## PLANNING CLEARANCE

BLDG ADDRESS 2289 EL MONTE COURT	TAX SCHEDULE NO. <u>2945-071-32-002</u>		
SUBDIVISION VISTA DEL RIO SUBDIU	SQ. FT. OF PROPOSED BLDG(S)/ADDITION 4011 3CAR GAR.		
FILING 2 BLK 2 LOT 2			
(1) OWNER STEVEN A. KING & DAUN M. KING	NO. OF DWELLING UNITS BEFORE: AFTER: THIS CONSTRUCTION		
1) ADDRESS <u>2415 Верариян</u> , G.J.Co (1) TELEPHONE <u>970</u> 242-8496	NO. OF BLDGS ON PARCEL BEFORE:		
12 APPLICANT WILCO ENTERPRISES	USE OF EXISTING BLDGS NONE		
(2) ADDRESS PO Box 3741	DESCRIPTION OF WORK AND INTENDED USE:		
(2) TELEPHONE 970 242-2203	SINGLE FAMILY RES		
REQUIRED: One plot plan, on 8 ½" x 11" paper, showing all existing & proposed structure location(s), parking, setbacks to all

VISTA DEL RIO SUBDIVISION ARCHITECTURAL CONTROL COMMITTEE CHECKLIST
DATE RECEIVED 10/02/97 \$30.00 FEE
BUILDER: WILCO ENTERPRISES PHONE 242-2203
ADDRESS: 569 5. WESTLATE, URAND JCF, CO
OWNER: STEVEN A. KING PHONE 242-8496
ADDRESS: P.O. BOX 896, WRAND JCT, CO 81502
SUBMITTAL FOR: FILING $Z$ LOT $\# Z$ BLOCK $Z$
SETBACKS: 255 COMMENTS ACCESSORY BUILDINGS: MONE FENCES: NOT SHOWN
ENGINEERED FOUNDATION: REQUIRED BY BULLING DEPARTMENT,
GEOLOGIC CONCERNS: HILLSIDE - MINIMIZE IRR. WATER ON S

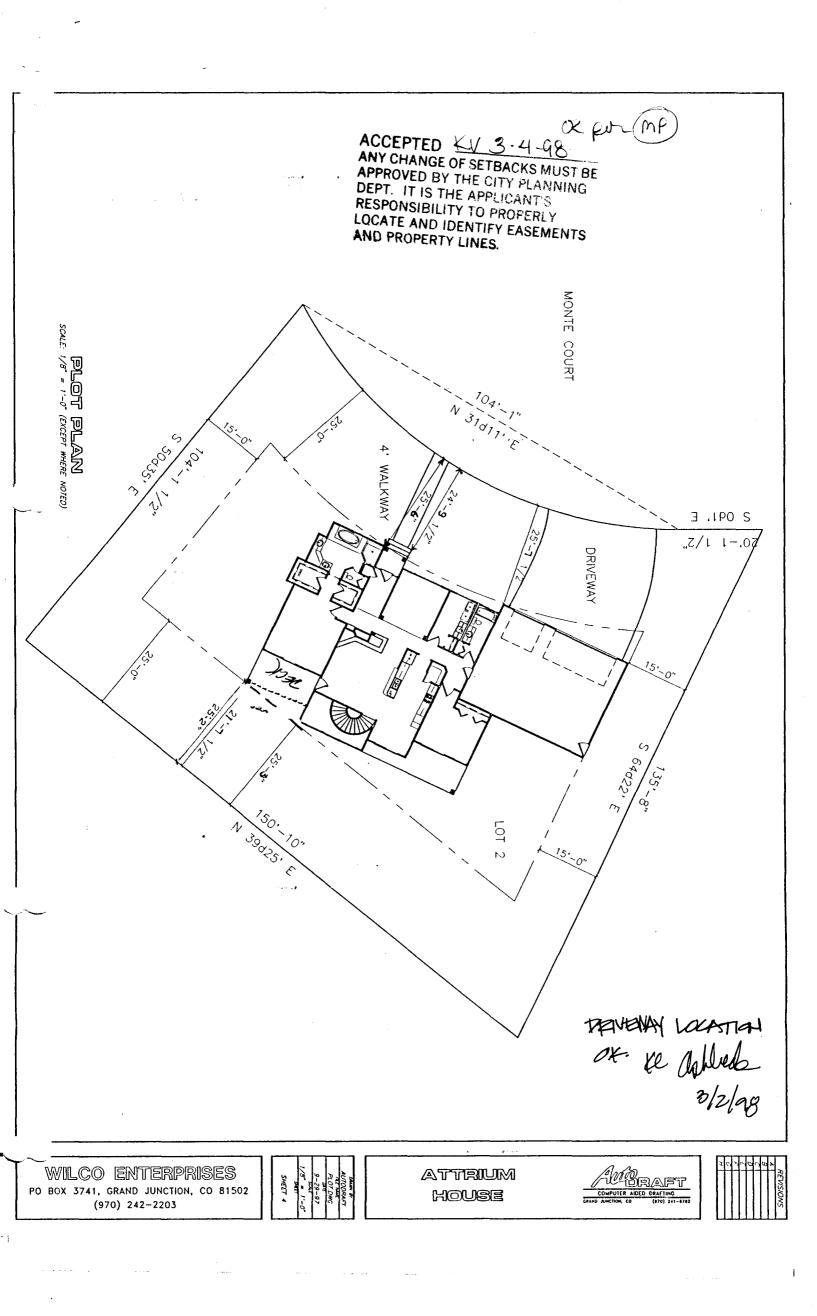
FOR REVIEW PRION TO INSTALLATION.
